**PLANNED UNIT DEVELOPMENT
& SUBDIVISION STAFF REPORT****Date: November 5, 2015****DEVELOPMENT NAME**

Cosgrove Subdivision, Revised

AREA OF PROPERTY16 Lots / 6.1 ± acres Subdivision
15 Lots / 6.1 acres PUD**CONTEMPLATED USE**Planned Unit Development Approval to amend a
previously approved Planned Unit Development to allow
reduced front, side, and rear yard setbacks and increased
site coverage in a proposed subdivision.**TIME SCHEDULE
FOR DEVELOPMENT**Roadway construction to be completed within the next
month, with total build out of houses within 3 years.**ENGINEERING
COMMENTS****Subdivision:** The following comments should be addressed prior to submitting the FINAL
PLAT for acceptance and signature by the City Engineer:

SITE PLAN

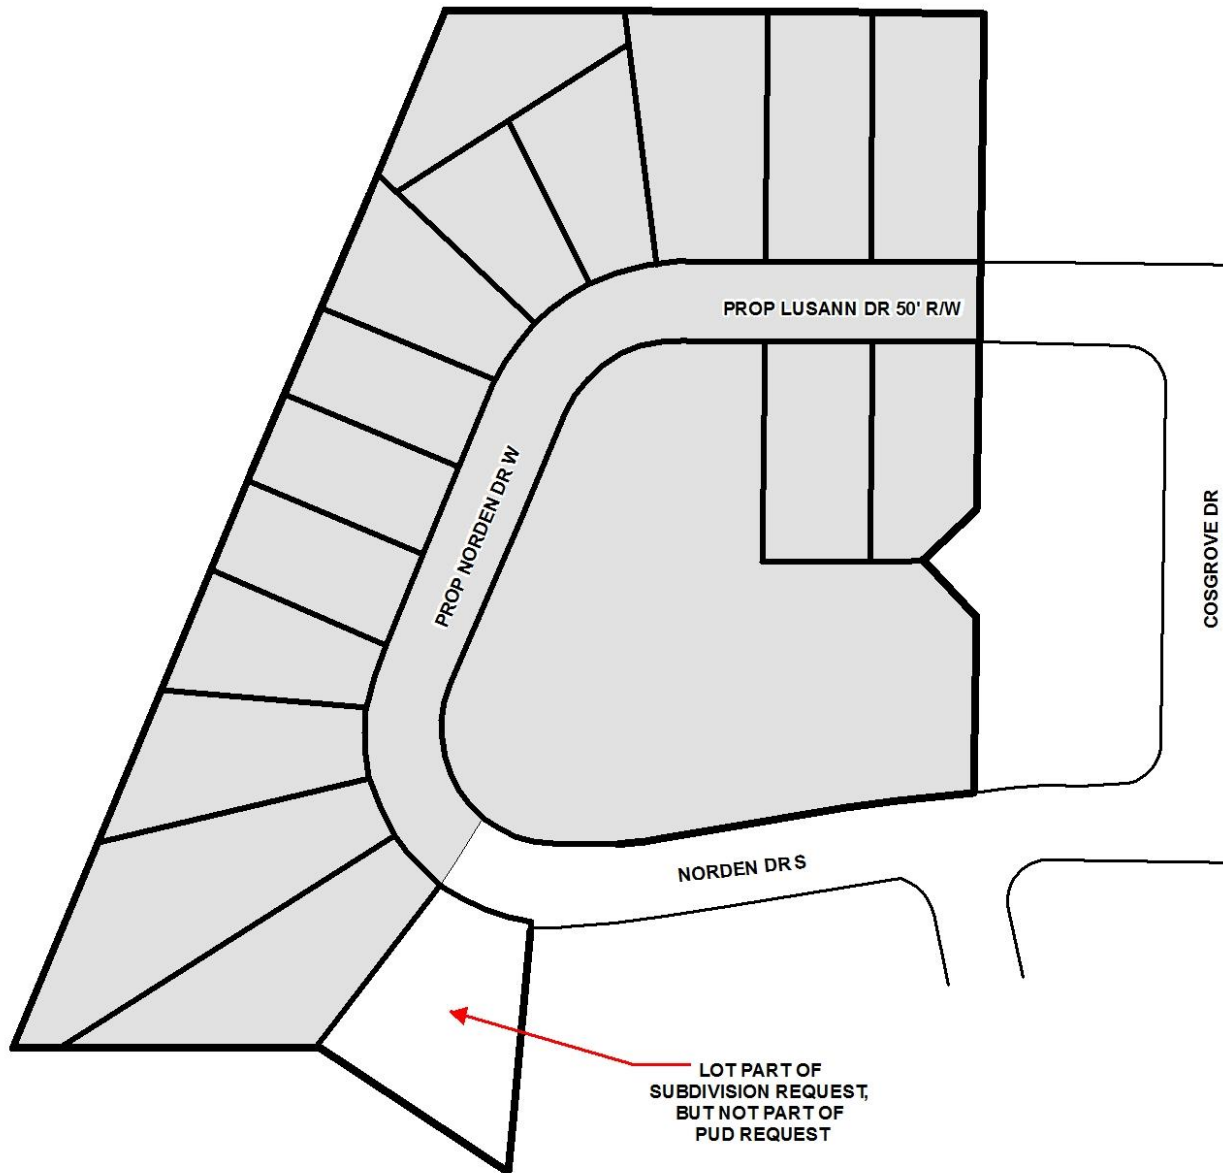
It should be pointed out that Lots 1, 13, and 14 abut existing, developed lots. Typically the side yard setback in PUD's is required to be at least 8 feet where the PUD abuts existing residential development. Therefore, a side yard setback of 8 feet should be required along the South boundary of Lot 1, and East boundary of Lots 13 and 14. It should also be pointed out that several of the lots have proposed drainage and utility easements ranging from 10 + feet in width, which will preclude the requested 5-foot side yard setback: thus the side yard setbacks for these lots, where they include the easement, should match the easement width on that side of the lot.

As the PUD site abuts the floodway and drainage easement for Twelve Mile Creek, safety is of concern. A six-foot high wooden privacy fence should be placed along the rear of Lots 2-8, where they abut the floodway and drainage easement for Twelve Mile Creek. The fence should be provided as each lot is developed, subject to Engineering approval due to possible drainage issues.

- 1) all new road construction must comply with Engineering Department requirements;
- 2) revision of the plat to depict the 15' minimum building setback lines along all street frontages for lots 1-15;

- 1) depiction and labeling of the front (15 feet +), side (5 feet) and rear (8 feet) setbacks for all lots, with the exception of Lot 1 which will have a side yard setback on the South boundary of 8 feet, and Lots 13 and 14, which will have a side yard setback on the East boundary of 8 feet, and for all lots where the side yard setback on one side shall match the width of the proposed drainage and utility easements, where the easements are greater than 5 feet;

- 4) revision of the "Proposed Lot Setbacks and Building Footprint Coverage" chart to depict the physical distance of the each lots setbacks instead of listing the word "easement";

- 5) revision of the site plan to depict and label the provision of a six-foot high wooden privacy fence placed along the rear of Lots 2-8, where they abut the floodway and drainage easement for Twelve Mile Creek, to be constructed as each lot is developed, subject to Engineering approval due to possible drainage issues;
